M.T Sweaters Ltd. Banga Fashion Ltd.

Plot # 1703-1704, Gacha, Gazipur Sadar, Dhaka
(23.93638N, 90.37576E)

12 March 2014

Typical Floor Plan

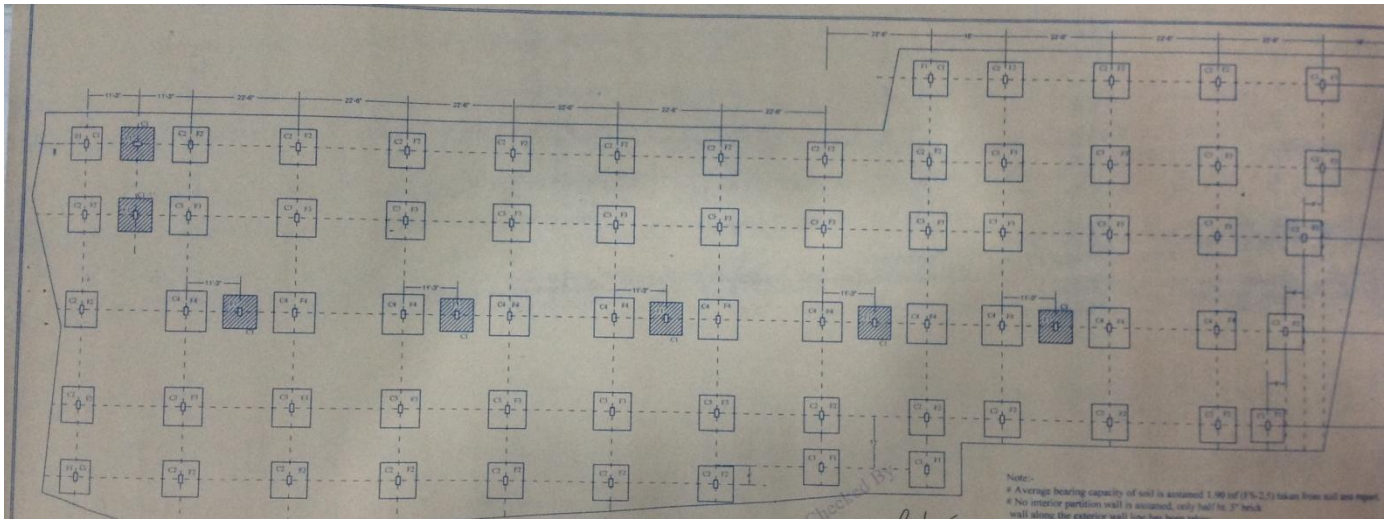
- Live loading on highlighted area to be reduced to 1.0kPa on 1st and 4th floors and area to be fully vacated on 2nd and 3rd floors.
- Loading on 5th floor not to increase from present loading

- Live loading on highlighted area between 1st and 4th floors to be reduced to 1.5kPa on 3rd floors and fully vacated on 1st floor.
- Loading on 5th and 6th floors not to increase from present loading

Column Strength

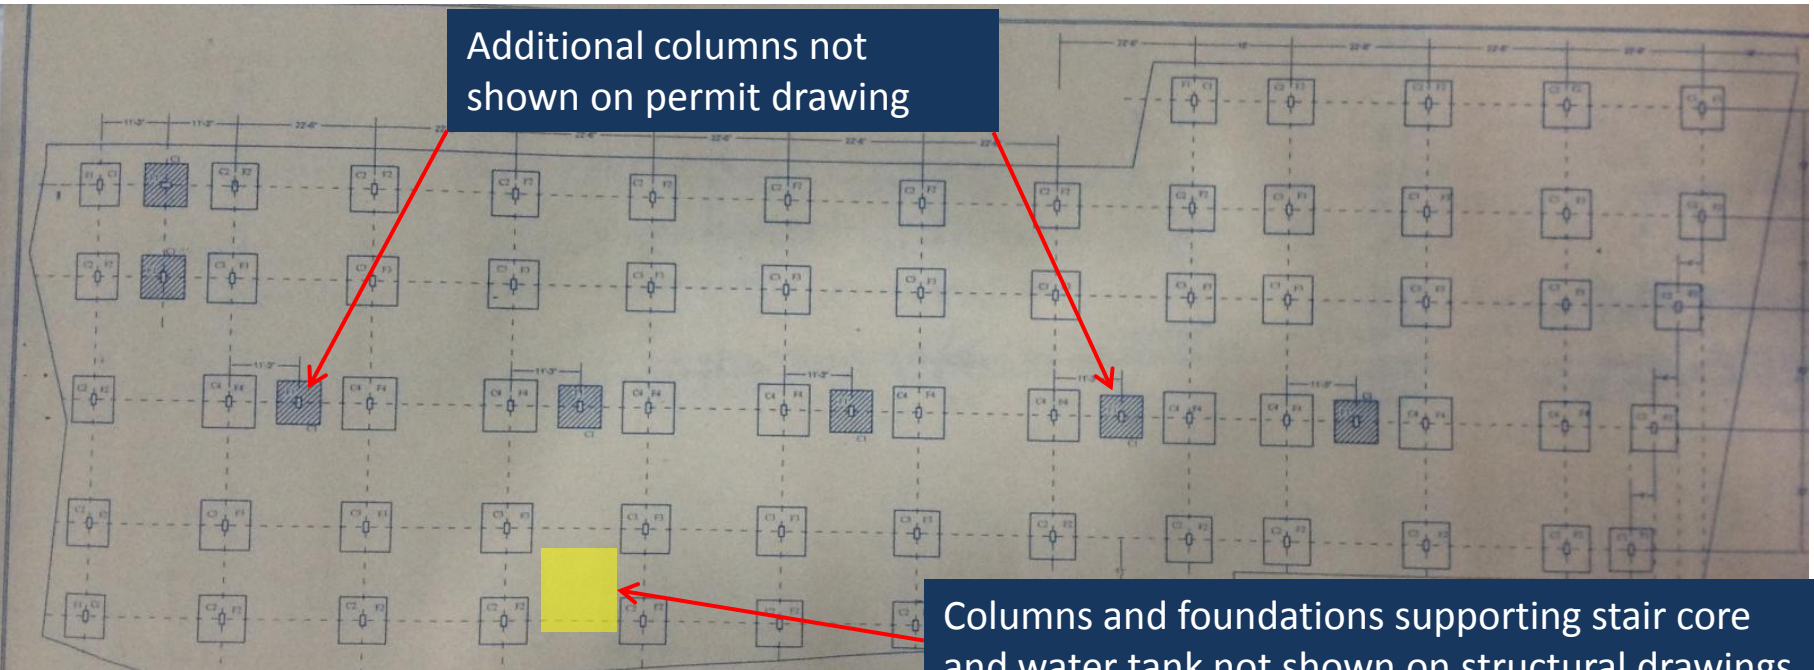
**Columns appear to be stressed to levels that
require immediate review**

Cursory calculations indicate that columns are stressed to levels that require immediate review

Specific design check to be carried out on columns at ground floor level which support roof level concrete water tank

**6th storey under construction.
Construction progressing from
north to south.**

**Column design check to consider if the additional
storey can be supported by the building columns
within the design code specified parameters.**

Building Engineer is to perform detailed calculations including a Detail Engineering Assessment (See attached scope) and concrete tests to prove column size and (if required):

- Further reduce loads by vacating floors
- Reinforce columns

Structural/Permit drawings not consistent

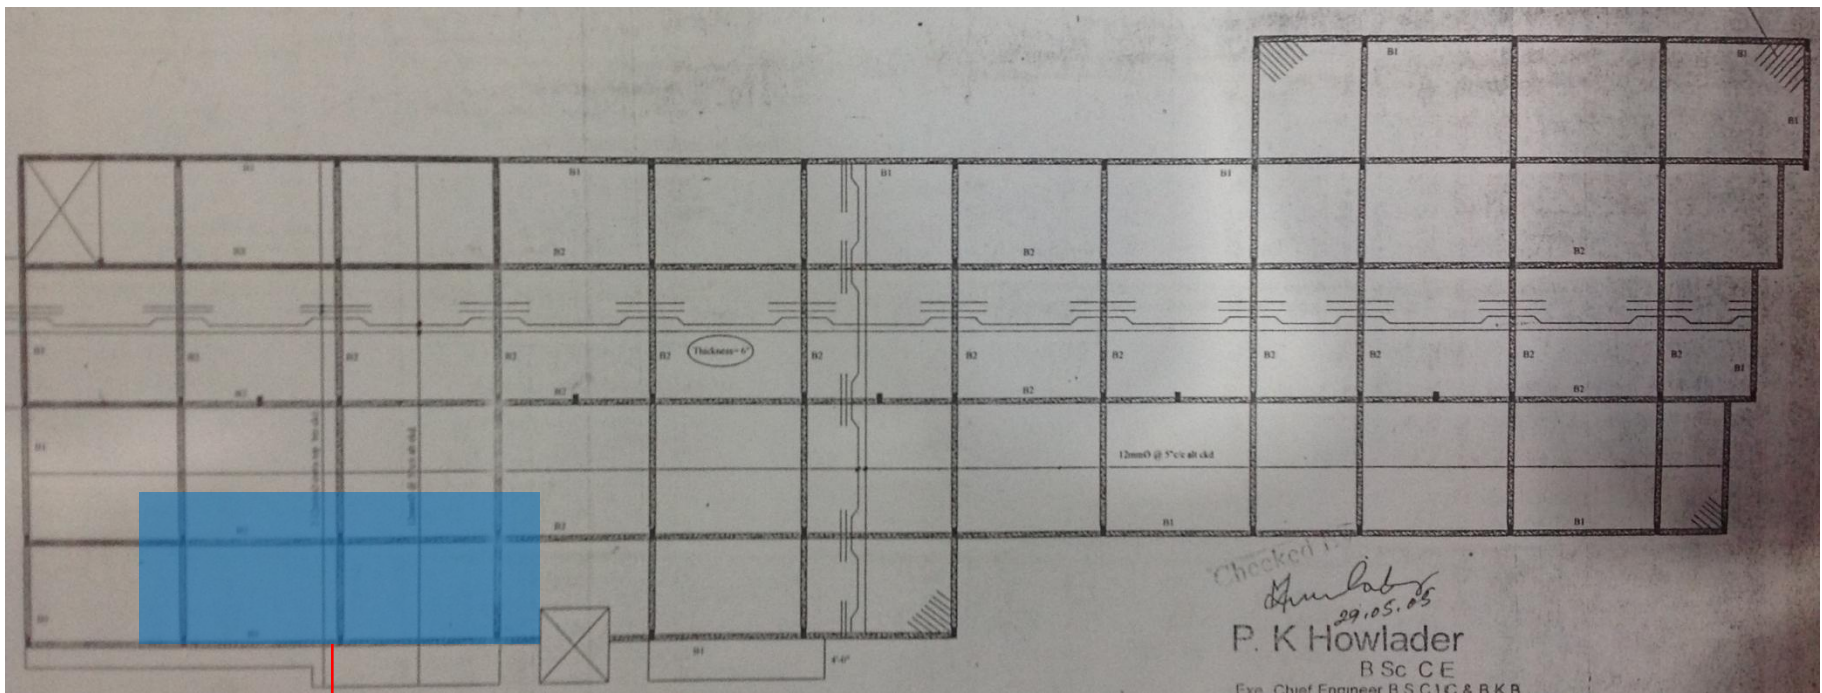
Structural design drawings are not consistent with the permit structural drawings – 4 storeys / 6 storeys.

Additional columns not shown on permit drawing

Columns and foundations supporting stair core and water tank not shown on structural drawings

Permit drawings show 6 storey factory building and structural drawings are for a 4 storey factory building with additional columns which are not included on permit drawings.

Building Engineer to survey as-built structure and update drawings

Floor build-up and equipment

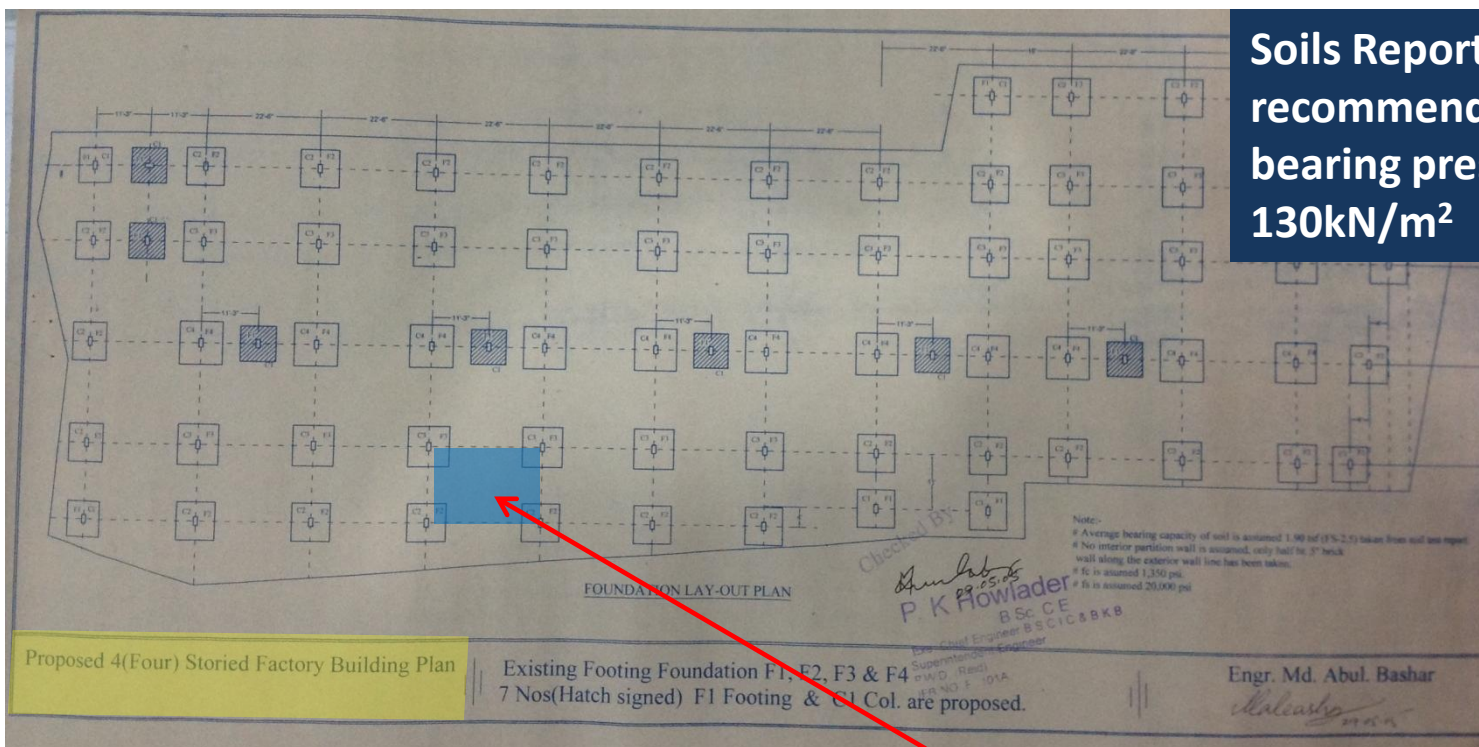
Design check required for Washer and Dryer loads on 1st and 4th floors to confirm floor slab load capacity

180mm (max) high floor build-up in Washer & Dryer Area including equipment loads supported by concrete slab on 1st and 4th floors.

Building Engineer to check that the slab has been adequately designed and constructed to carry additional load due to floor build-up and equipment in these areas.

Structural Foundation Plan

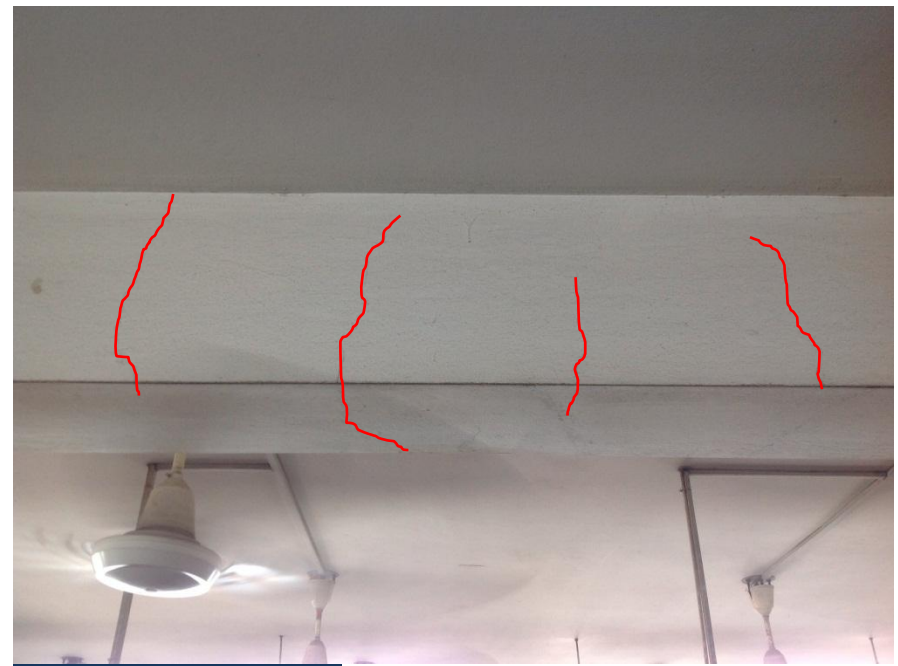
Estimated foundation bearing pressure in excess of Soils Report recommendation

**Soils Report 2013
recommends allowable
bearing pressure of circa
130kN/m²**

Foundations shown appear to be designed for a four storey factory building (highlighted yellow). Building Engineer to confirm bearing capacity of pad footings in all areas.

Foundation not indicated under stair core and water tank (area highlighted blue). Building Engineer to confirm presence and bearing capacity of foundation at this location

Beam Cracking

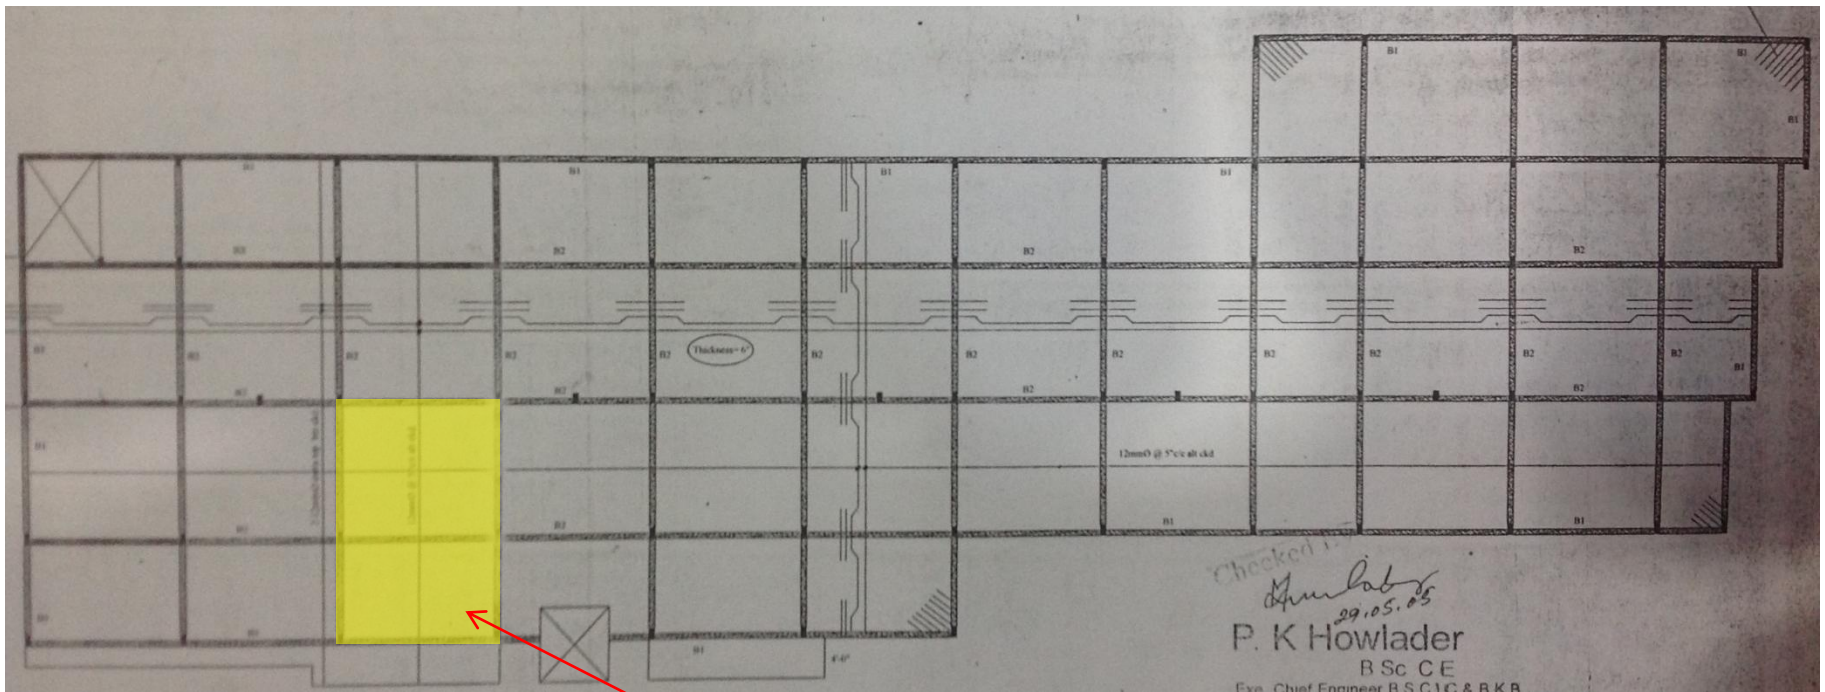
Hairline cracking of beams on a number of floors

Beam and slab cracks to be reviewed on all floor levels by removing plaster to confirm that cracks do not extend into structure.
